14 February 2024

Urban Design Hearing Statement

Proposed landscape plan

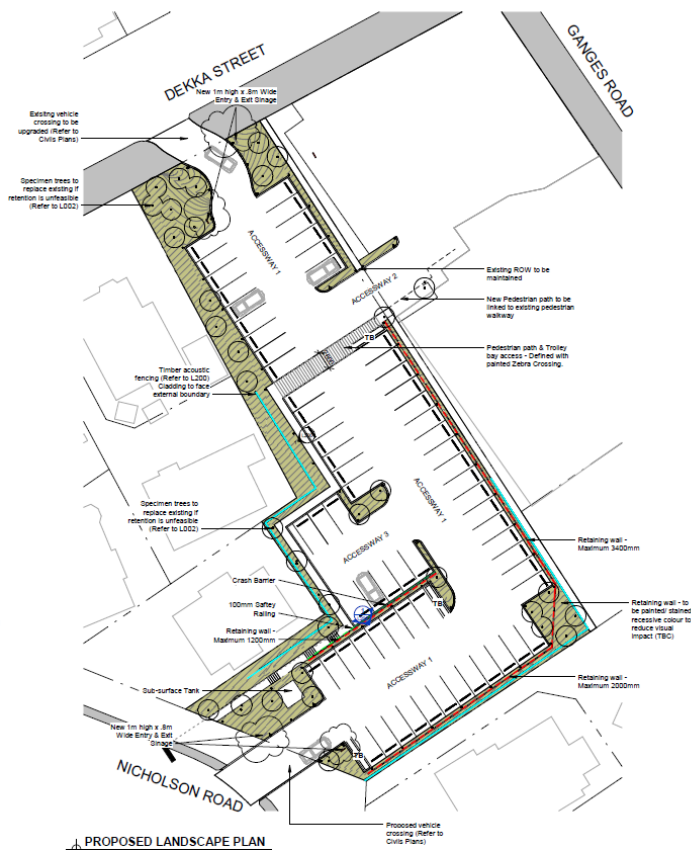
As the proposal comprises a large open car park, it will be inconsistent with the relevant guidelines of the Residential Design Guide which seek to reduce vehicle dominance, both from the street and from within the site. The application has included a landscaping plan for the proposal, which will provide some visual amenity and softening at the external boundaries. However, the site itself will have no variation of surface treatments and minimal landscaping beyond what is proposed at external boundaries. Most of the north-eastern external boundary comprises grasses, which will provide minimal softening or visual relief.

A landscaping plan has been provided for the development, which includes a range of species that should be relatively low maintenance and hardy. With the exception of areas previously mentioned that would be improved with more planting (rear retaining walls and Nicholson Road frontage), the landscaping is considered appropriate. However, this should not be considered to compensate for, or override the more substantive urban design concerns raised such as residential character, especially on Nicholson Road, and visual mitigation of the retaining wall discussed above.

Figure 4: Double vehicle crossing proposed on Nicholson Road

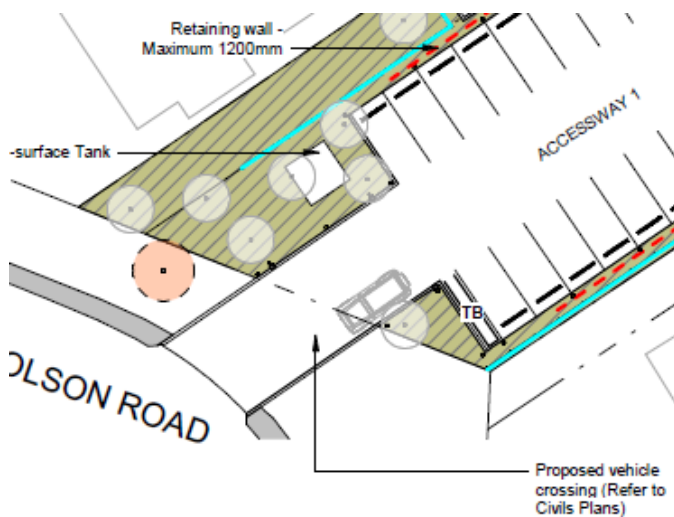
4.6 With the introduction of an open car park, the extent of hardscaping on 33 Nicholson Road will be significantly more visible from the street, compared with the Dekka Street frontage. The proposal does not include any fencing along the frontage, and the proposed landscaping will not be sufficient to screen the double width vehicle access and car parking behind.

8.2 There is a preference for there to be no vehicle access in or out of the Nicholson Road frontage, in which case only a pedestrian sign would be required. In the event the Council planner is able to support vehicle access on Nicholson Road, I would recommend this is limited to only a single width access, which will also reduce the number of signs required at the frontage.
